Based on the comments received, I would like to provide the following responses:

1. Hunter Mews Clarification

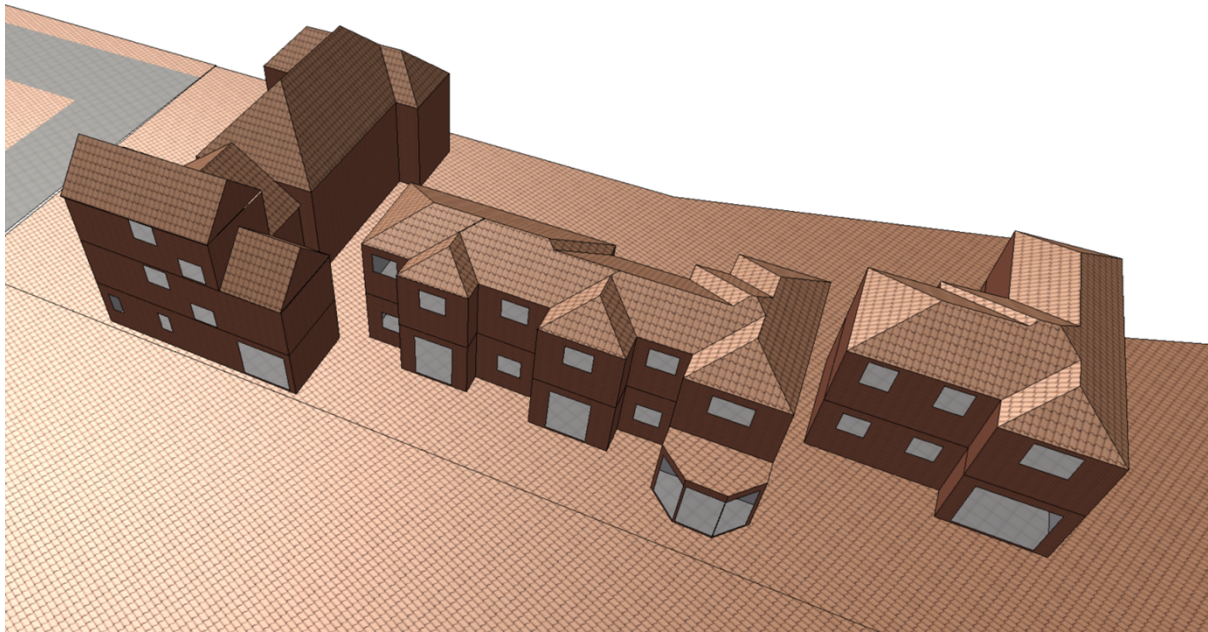
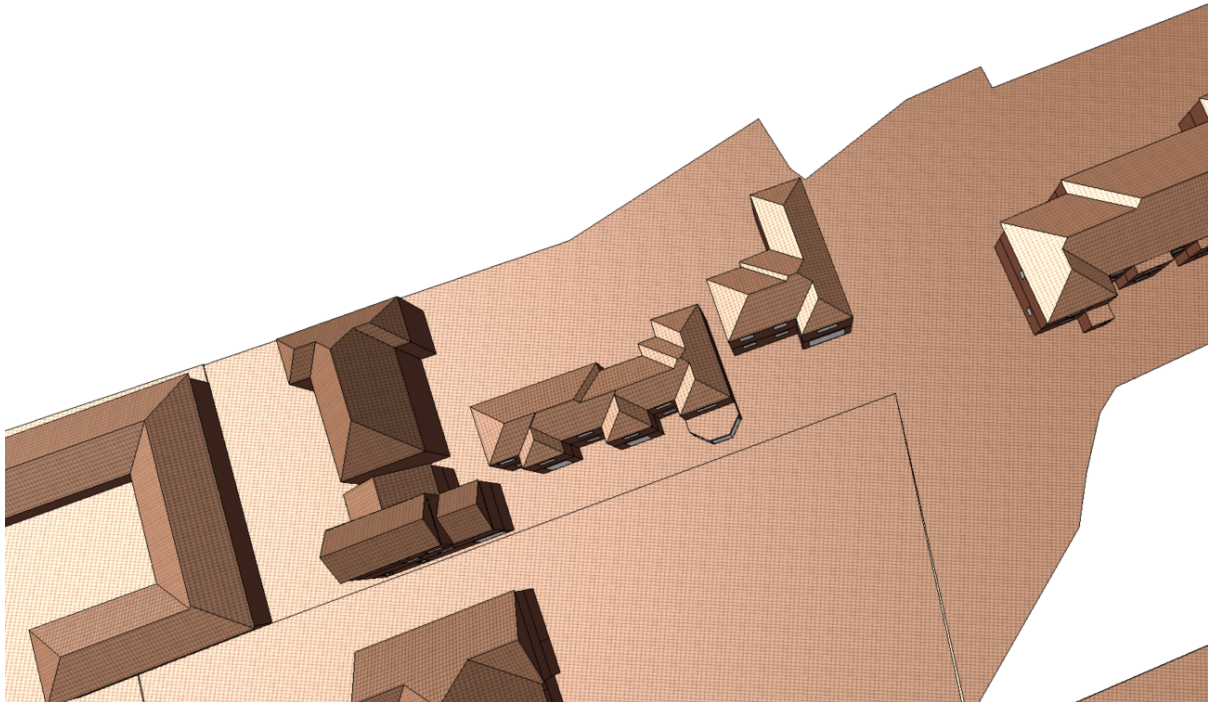
Due to limited information initially available, 31–33 Hunter Mews was referred to collectively as "Hunter Mews" in the report. This includes:

- 33 *Hunter Mews* – a 3-storey detached house
- 31–32 *Hunter Mews* – a block of three 2-storey maisonettes

Please note, 30 *Hunter Mews* (a detached house) is addressed as 30 Dog Kennel Lane.

I can confirm that during daylight modelling, these properties were **not cloned as a single unit**. This is demonstrated in the images included in Appendix D and E, specifically Figure E1 of the issued report, which shows each property modelled individually. Additionally, I have attached aerial-view model images below for further clarity. The existing buildings were accurately positioned using the site layout and topographical survey drawings for the daylight and sunlight assessment.
